Access Compliance Report

Public Rights-of-Way

(Curb Ramps)

Intersection ID: 53391	Main Street: EBBETS_RD	Cross Street: VAWTER_DR	Location:	NE
ADA ID: 2CA41D8E46CC	Ramp Type: BlendTrans1	Initial Pass/Fail: Fail	Overall Compliance: No	Severity Score: 10
Codes/Mitigation Info/Possible Solution		Field Measurements/Component Compliance

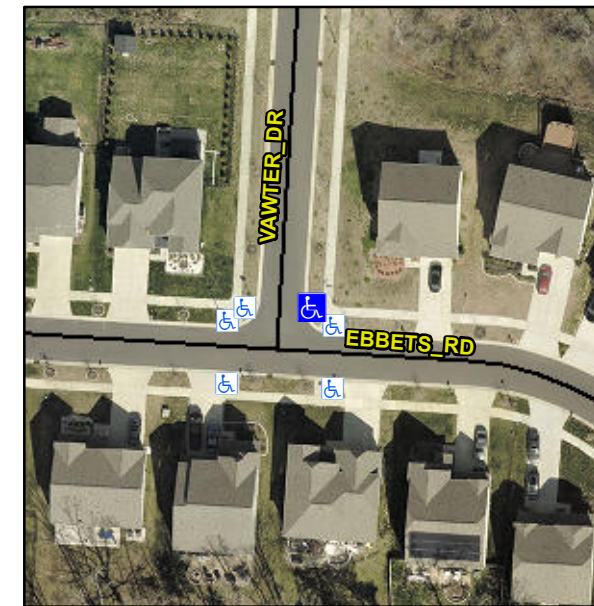
Not Found, R304.5.1, R304.5.3

Compliance	Description	Data	Compliance	Description	Data
N/A	Ramp Length (in)	95.0	Yes	BlendTrans Slope (%)	2.3
No	Ramp Width (in)	36.0	No	BlendTrans XSlope (%)	2.4
N/A	Flare Type LT	N/A	N/A	Flare Type RT	N/A
N/A	Flare Slope LT (%)	N/A	N/A	Flare Slope RT (%)	N/A
N/A	Flare Traversable LT?	N/A	N/A	Flare Traversable RT?	N/A
N/A	Landing Length (in)	N/A	N/A	DWS Provided?	N/A
N/A	Landing Width (in)	N/A	N/A	DWS Contrast?	N/A
N/A	Landing Slope (%)	N/A	N/A	DWS Length (in)	N/A
N/A	Landing X Slope (%)	N/A	N/A	DWS Full Width?	N/A
N/A	Landing Curb? (Y/N)	N/A	N/A	DWS Offset (in)	N/A
N/A	Shared Landing?	N/A			
N/A	Gutter Ponding?	N/A	N/A	Gutter Slope (%)	N/A
N/A	Gutter Lip Ht (in)	N/A	N/A	Gutter X Slope (%)	N/A
N/A	Painted X Walk1?	No	N/A	Painted X Walk2?	N/A
	X Walk 1 Direction	To W		X Walk 2 Direction	N/A
	X Walk 1 Width (in)	N/A		X Walk 2 Width (in)	N/A
	X Walk 1 Slope (%)	2.0		X Walk 2 Slope (%)	N/A
	X Walk 1 X Slope (%)	4.3		X Walk 2 X Slope (%)	N/A

N/A	Ramp inside XWalk1?	N/A	N/A	Ramp inside XWalk2?	N/A
	Road Slope (%)	4.3		Clear Space?	N/A
	Road X Slope (%)	2.0	N/A	Clear Space to XWalk (in)	N/A
N/A	Any Obstructions?	N/A	N/A	Storm Grate/Utility Hazard?	N/A
	Obstruction Type			Storm Grate/Utility Type	
		N/A			N/A
			Yes	Surface Condition? (G/P)	Good
			No	Curb Slope (%)	5.1

Remove & Replace Curb Ramp With Two New Directional Ramps or Equivalent.
